Construction Traffic Management Plan Parramatta

Project Name:	Sydney Metro West		
Client Name:	Transport for New South Wales		
Project Address:	Delta will undertake demolition and utility works at the following sites: 1. Clyde 2. Parramatta 3. Westmead		
Project Description/Scope:	DELTA Pty Ltd (DELTA) is responsible for the demolition of existing structures including removal of all hazardous materials and utility works of the Sydney Metro West Project at Clyde, Parramatta and Westmead		
Prepared By:	Name: [REDACTED]	Signature: [REDACTED]	Date: 14 th October 2021
Reviewed By:	Name: [REDACTED]	Signature: [REDACTED]	Date: 14 th October 2021
Authorised By (Project Director):	Name: [REDACTED]	Signature: [REDACTED]	Date: 14 th October 2021

<i>Rev</i>	<i>Date</i>	<i>Description</i>	<i>Page</i>	<i>Developed By</i>	<i>Approved By</i>
0	16/09/2021	CTMP Initial submission	All	[REDACTED]	[REDACTED]
1	5/10/2021	CTMP revised based on comments received from Sydney Metro, CJP, City of Parramatta Council	All	[REDACTED]	[REDACTED]
2	14/10/2021	CTMP revised based on comments received	All	[REDACTED]	[REDACTED]
3					
<i>Distribution Register</i>					
<i>Rev No.</i>	<i>Date of Issue</i>	<i>Name of R

Figure 14: Traffic arrangements mid-September 2021 to Christmas 2021

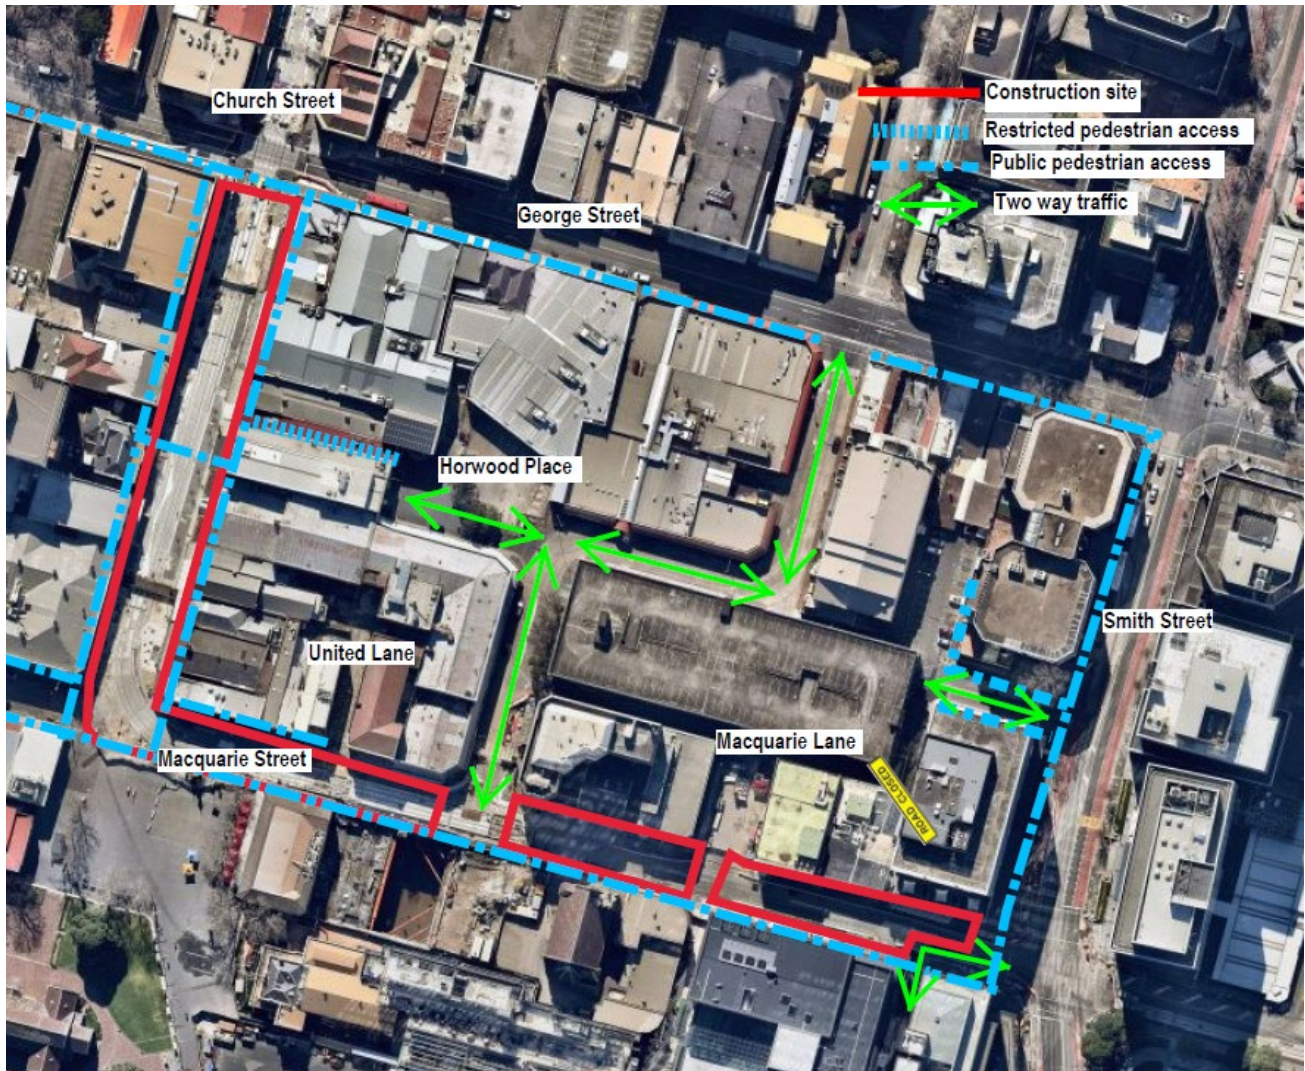
1/10/2021	City of Parramatta Council	[REDACTED]	0	7.2 Operating Conditions for onsite works		Figure 13. - What do dotted green lines represent?	Observation		Figure amended - local 2 way access

TCP No: TGS-PAR-HOR-SB-2201	SIGNATURE: <i>Sue Lewis</i>		Signature:	
Sheet No: 1 OF 1	PLAN CHECKED BY: SUE LEWIS		Date:	
	CERTIFICATE NO: 0022818927		Ticket: Orange/Red/Yellow (Circle Appropriate)	
	SIGNATURE: <i>Sue Lewis</i>		Ticket No: _____

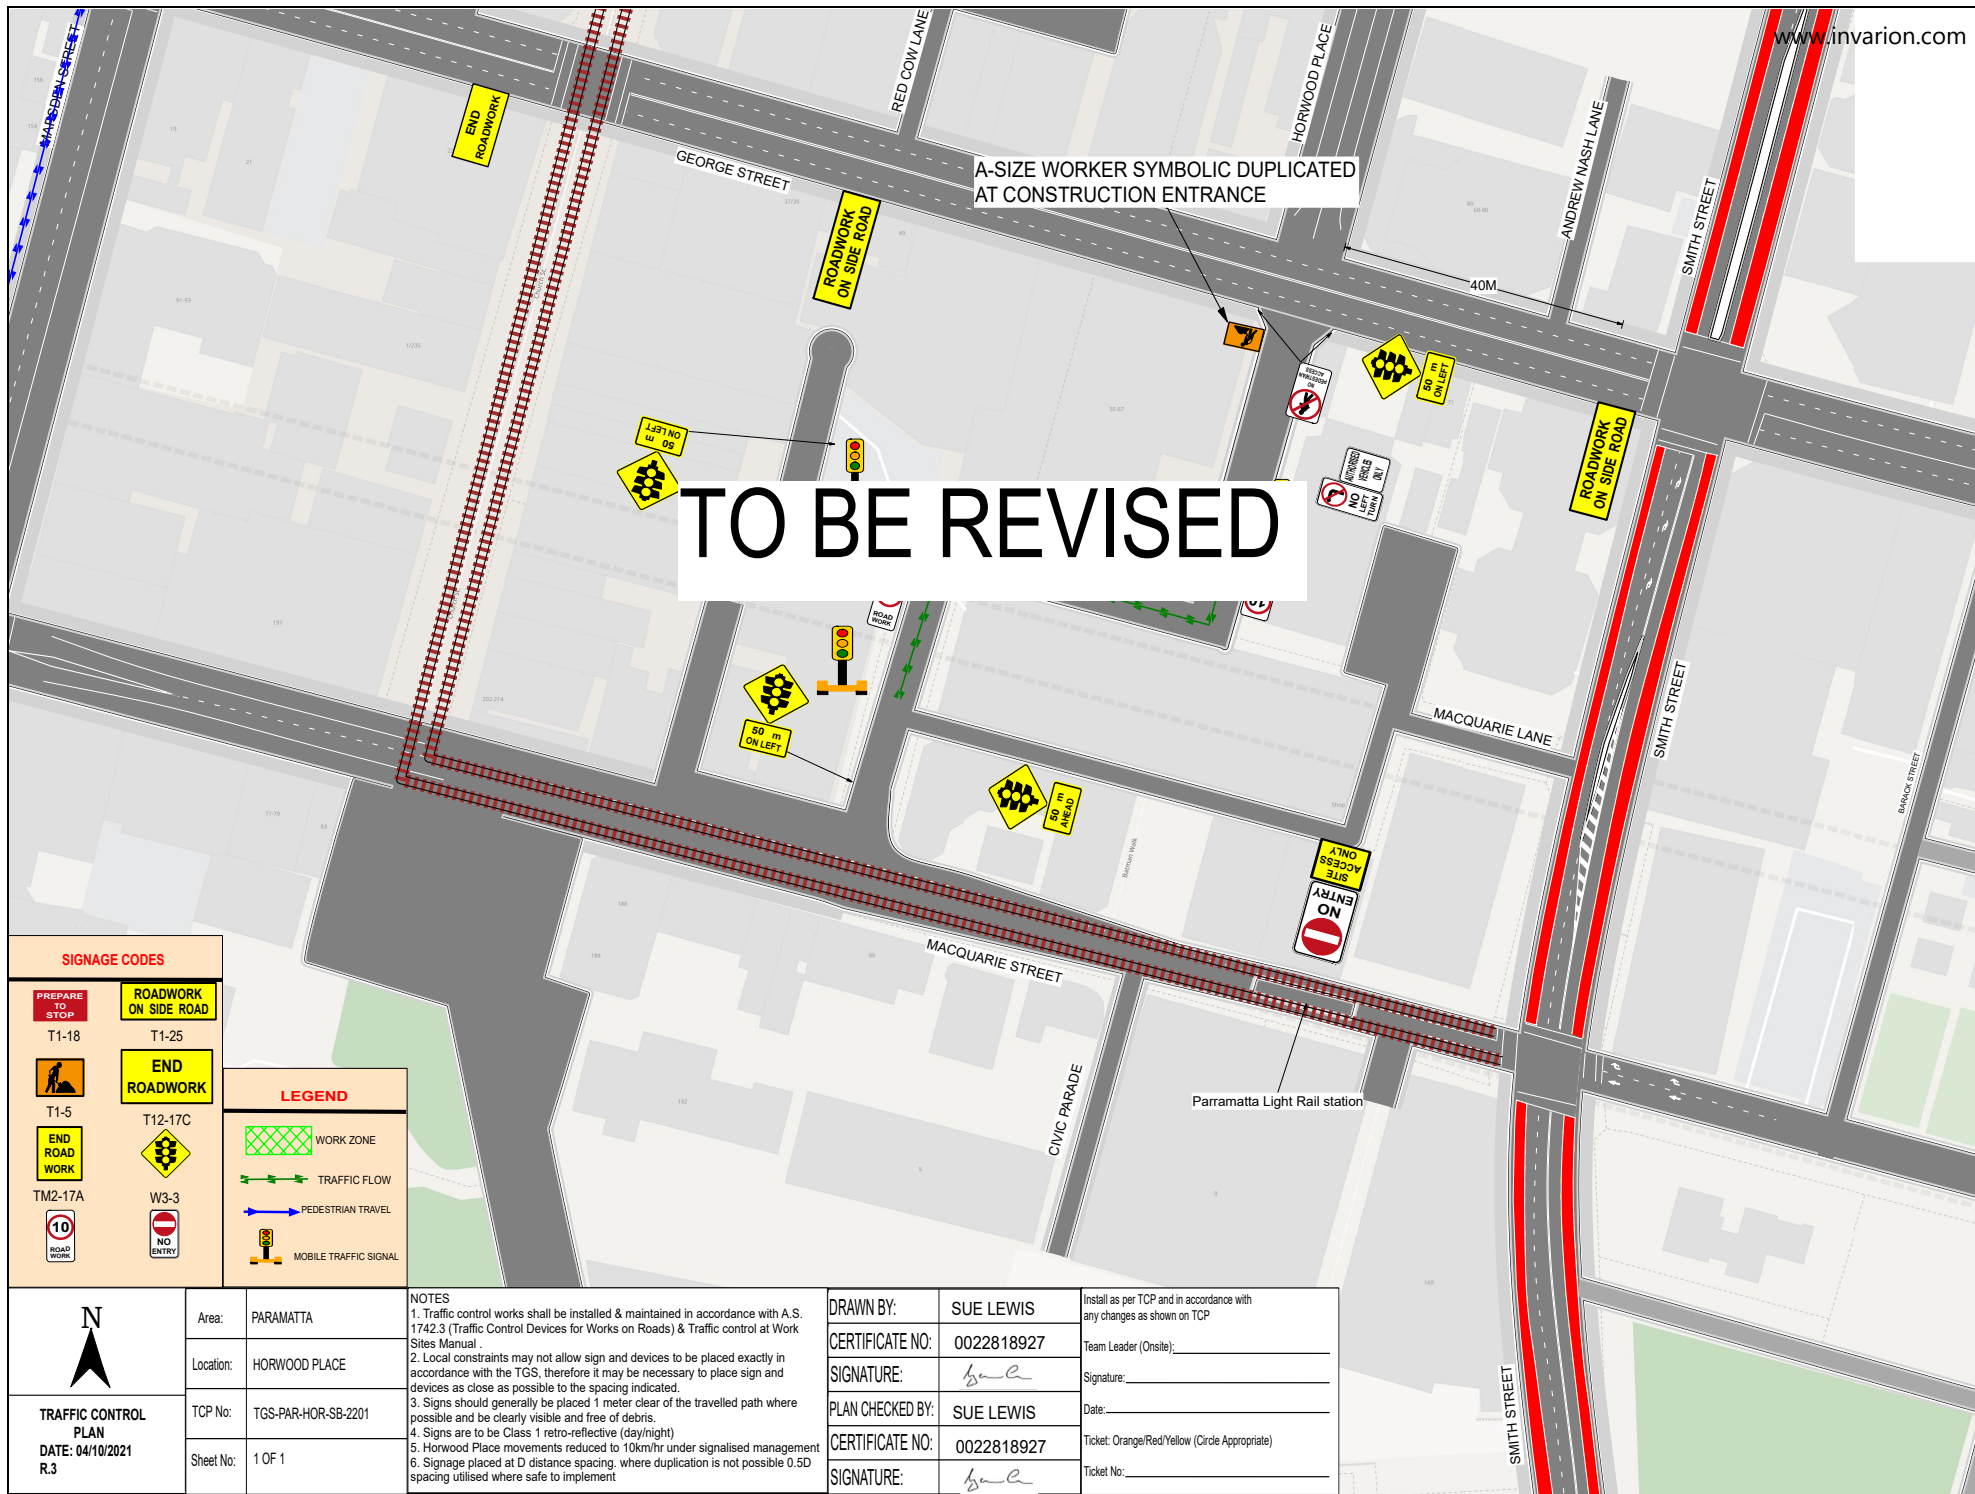
2	Appendix C - • TGSPARHORSB2201	<p>Location of the Worker symbolic sign (T1-5) appears to be located in a position that will not provide benefit.</p> <p>The T1-5 sign should be located in advance of areas where workers will be visible to passing traffic. These areas appear to be:</p> <ul style="list-style-type: none"> - Intersection of Church St & George St - Intersection of Macquarie St & Smith St - Approaching Macquarie St from Civic Pde <p>Using the T-5 sign in areas not required can lead to drivers 'loosing respect' for the sign. The loss of 'respect' may result in increased risk to workers.</p>	Improbable	Minor	Low	<p>The worker symbolic sign has been relocated to within Horwood Place as this is the only location where the public will see workers</p>
3	Appendix C - • TGSPARHORSB2201	<p>It is unclear if the TGS is for long term use. If the TGS is to be implemented for long term use, signs should be mounted in a long-term manor.</p> <p>Installing a long term TGS in a temporary state may lead to signs being moved or falling over, increasing the risk of nose to tail & head on type accidents, with insufficient warning of the signals.</p>	Improbable	Minor	Low	<p>Where possible the signs will be installed long term - however the initial installation and demolition works are substantially complete the signs will be installed in a temporary manner</p>
